IN THE MATTER OF)
) Docket No. 72-1050
HOLTEC INTERNATIONAL)
)
(Consolidated Interim Storage) September 14, 2018
Facility Project))

Concurrently with the application for a license, Holtec has submitted an environmental report (ER) and a safety analysis report (SAR). Radioactive waste would be transported to the CIS site by rail or truck from various reactor sites around the country. The transportation and storage of the radioactive waste as proposed by Holtec

Figure 7.C.1

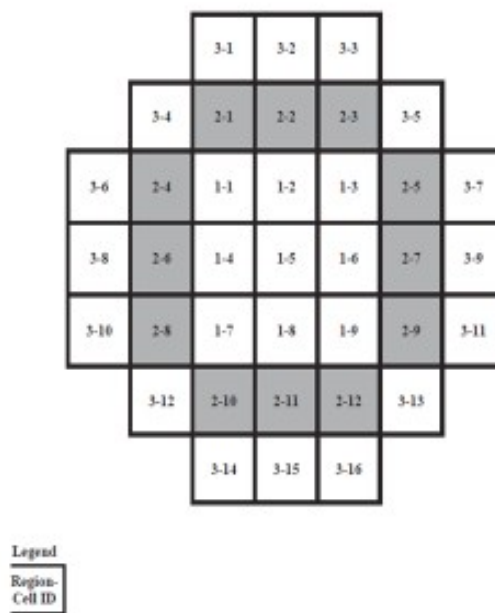
The loading for the MPC-37 is quite complicated, so it may be an issue whether utilities can follow the prescriptions outlined by Holtec. One example is shown below in Figure 1.

Figure 2

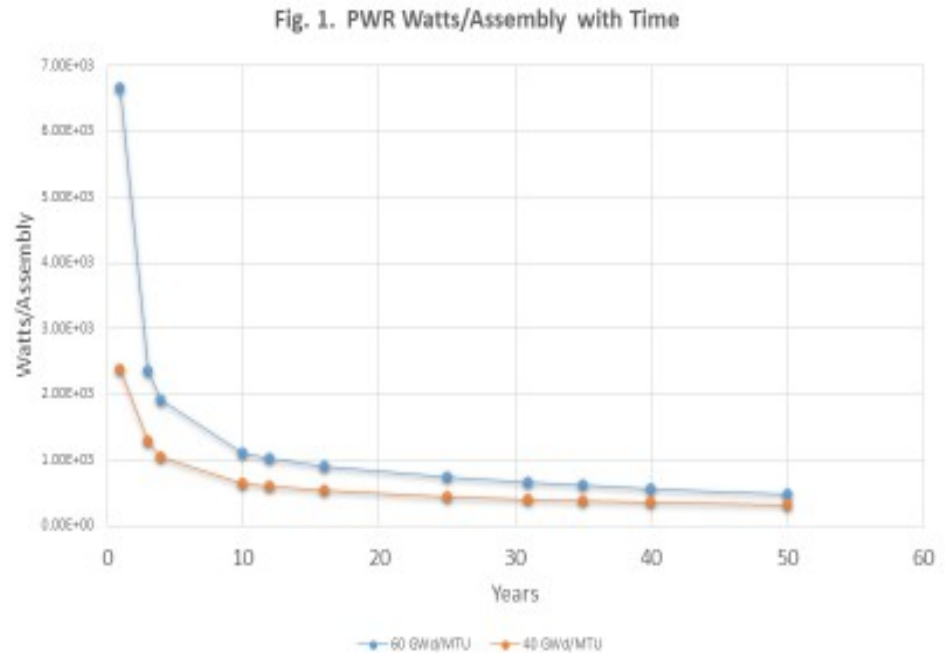
Dr. Marvin Resnikoff has calculated the time for shipping, based on the third figure. Dr. Resnikoff took all of the radionuclides that are present in high burnup and medium burnup fuel. This is the same radionuclide mix used by Holtec. Roddy, J.W., et al., Physical and Decay Characteristics of Commercial LWR Spent Fuel (1986), found at inis.iaea.org/collection/NCLCollectionStore/_Public/17/065/17065841.pdf. As shown in Figure 2 below, in the first 10 years there is exponential decay but after 10 years

up to year 75, decay is quite gradual and it takes so long for fuel to cool down.

The basic reason why this happens is because of the decay of one of the plutonium isotopes, plutonium 241, to americium 241. Americium 241 has a long half life, 423 years, so it acts as a reservoir for the plutonium 241 decays. By year 75, americium 241 accounts for approximately 25% of the heat output.

FIGURE 5.3.14: HI-TRAC 100 AND 100D TRANSFER CASK CROSS SECTIONAL VIEW (AS MODELED)

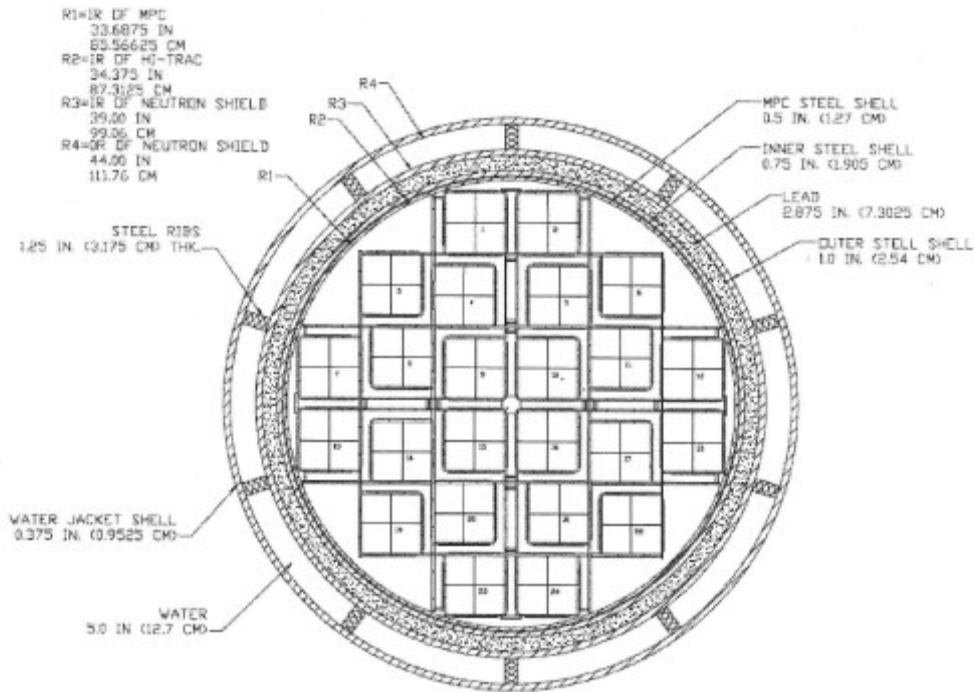
Since the HI-TRAC CS cask details are not available because they are being withheld by Holtec as proprietary, the public cannot confirm the Holtec calculations nor confirm that safety is assured. For the HI-TRAC 100, the cask details are provided, as seen in Figure 3 below.

Dr. Resnikoff used this drawing, at least within a factor of 2, to verify the dose rates calculated by Holtec in the HI-STORM FSAR. Dr. Resnikoff has not been able to locate a

similar drawing for the HI-TRAC CS, which is constructed with concrete and steel shells, rather than lead and steel shells. The similar drawing for the HI-TRAC CS is being withheld by Holtec as proprietary.
